AGENDA

Planning Committee Meeting to be held at
Darebin Civic Centre,
350 High Street Preston
on Monday 14 November 2022 at 6.30pm.

**5.1 APPLICATION FOR PLANNING PERMIT D/745/2021
700 HIGH STREET THORNBURY**

Figure 2 – Aerial image of 700 High Street (Nearmap, 14 September 2022)

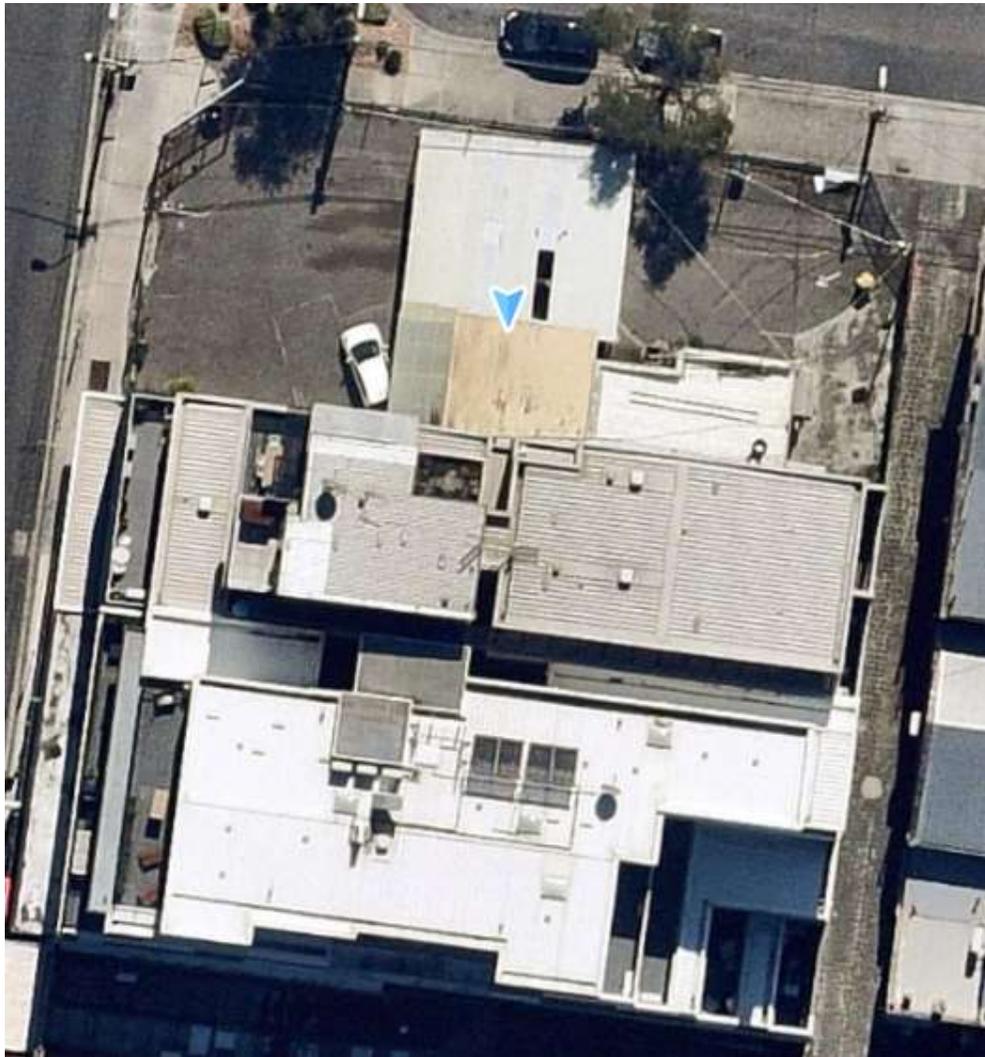
The existing laneway incorporates a width of three (3) metres. In the current design of the proposal a B85 vehicle would require partial manoeuvrability occurring on public land. As a result, the permit will be conditioned to require the lift core and entire central core shifted 200mm towards High Street to enable vehicle maneuverability to occur entirely within the subject site and rear laneway without encroaching into the footpath area on Gooch Street. This ensures adequate aisle width, including the laneway of 3 metres, for convenient vehicle manoeuvrability as deemed acceptable by Council's traffic engineers.

Requiring the laneway to be widened to six (6) metres for the width of the rear of 700 High Street, up to the boundary with 692 High Street, would not serve as either functional nor provide additional benefit. It would concurrently be impractical to have the full length of laneway interface widened for a length of 13.716 metres and then to retain its original width for the remainder of the laneway. This may be a design aspect which could be implemented into a proposal adjoining a laneway which does not include adjoining major existing developments built to the boundary of the laneway, however, in relation to the application in question, it is neither practical nor necessary.

Figure 3 – Diagram 1A in Clause 22.05

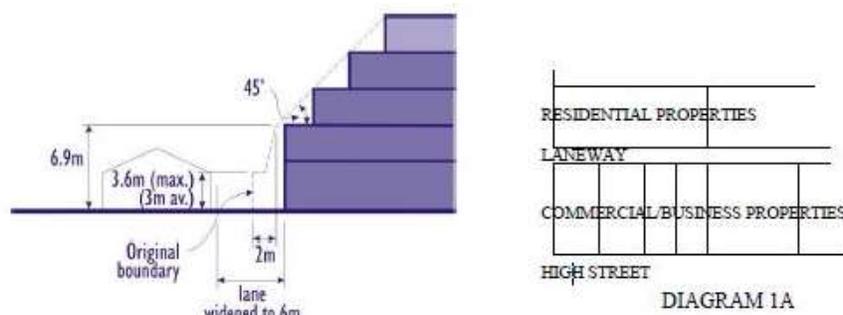
New development is required to have rear setbacks adjacent to residential properties in accordance with the diagrams below:

The proposal does not incorporate the above required setbacks. The rear setback requirements are in relation to adjacent residential properties. The property located due east of the subject site is 2 Gooch Street, which includes a double storey commercially operated building. The building is located within a Heritage Overlay (HO283), identified as the *former UFS Dispensary*.

Figure 6 – Proposed streetscape elevation of the proposal in question

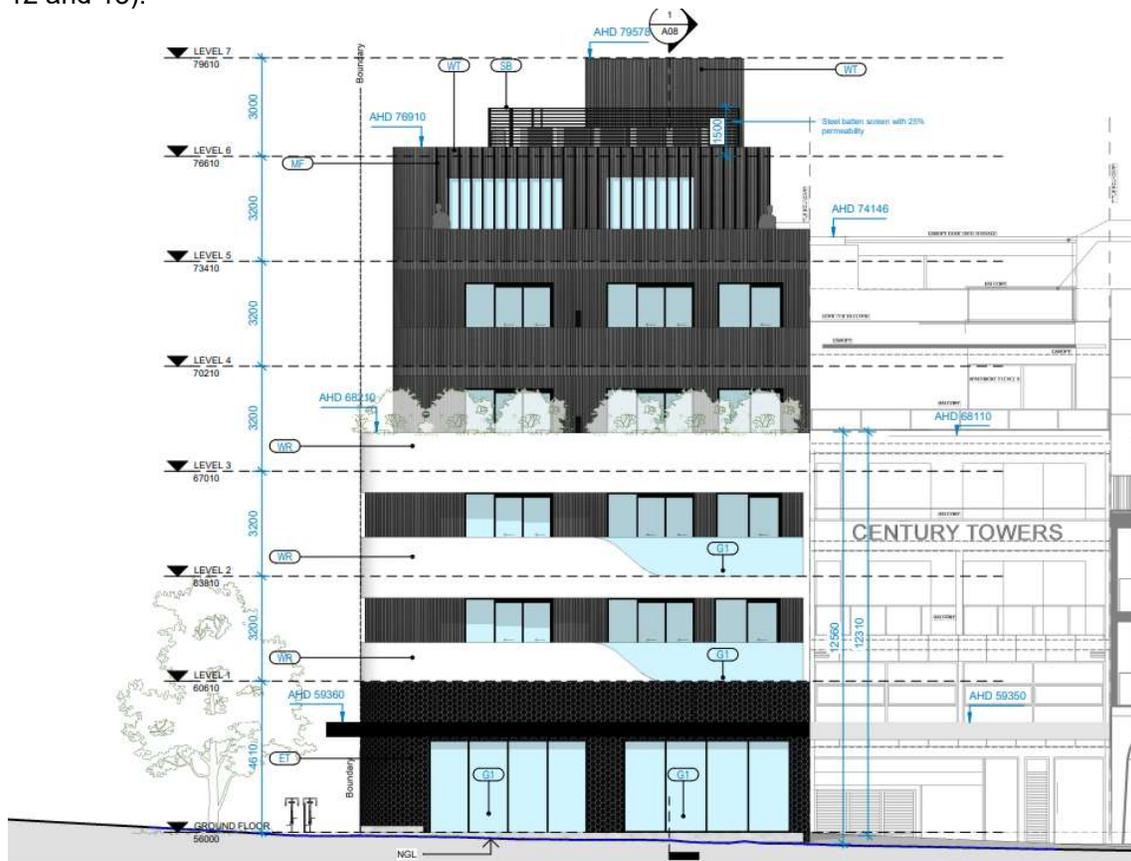
The application is seeking a variation to the above design parameter, whereby the ground floor storey is proposed at 4.61 metres in height, with each storey above proposed to be 3.2 metres in height. This minor variation is acceptable in the context of the existing streetscape, particularly as the ground floor component is broken up through the inclusion of the weather protective awning which is to be 3.01 metres in height, placed to match the height of the existing awning to the building adjoining due south (692 High Street), as recommended by Council’s City Designer, and successfully incorporated into the proposal (refer to figures 11, 12 and 13):
